TSG RAN Working Group 1#9
Dresden, Germany, November 30 – Dec 3, 1999-11-23

Agenda: AH14
Source: GBT
Title: CR 012 to TS25.211 CPCH-related editorial changes for clarification
Contribution for Approval

25.211 CR 012

Subject: **CPCH-related editorial changes for clarification**

Figure xxx: Frame structure for uplink CPPDCH/CPPCCH

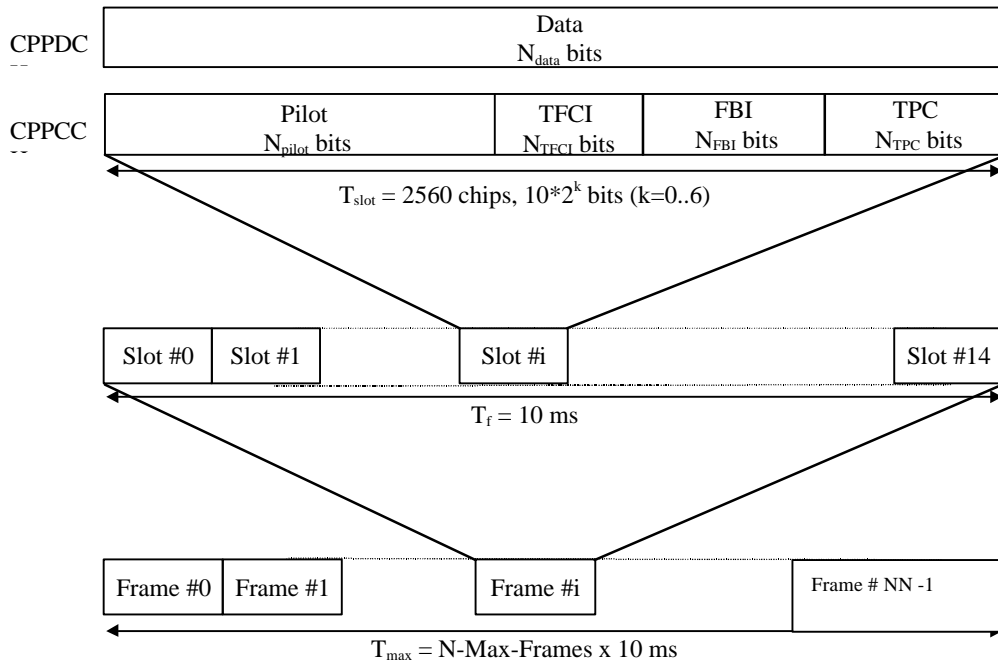
3. There is no figure to describe the structure of the CPCH message part as compared to Figure 5 in the RACH section. It is different from RACH because besides of pilot and TFCI it also contains TPC. Also the frame structure should be included from Frame 0 to Frame $N_{Max_frames} - 1$

Proposed Figure addition to section 5.2.2.2.5 of 25.211

N_{Max_frames} is referred to as NN in the following Figure. Figure xxx shows the frame structure of the uplink common packet physical channels. Each frame of length 10 ms is split into 15 slots, each of length $T_{slot} = 2560$ chips, corresponding to one power-control period. A super frame corresponds to N_{Max_Frames} consecutive frames. Note that the T_{max} , maximum packet length is equal to $N_{Max_frames} \times 10$ ms.

The spreading factor may vary in time (per frame). However, the SF factor can never be lower than the initially UTRAN-granted Spreading Factor.
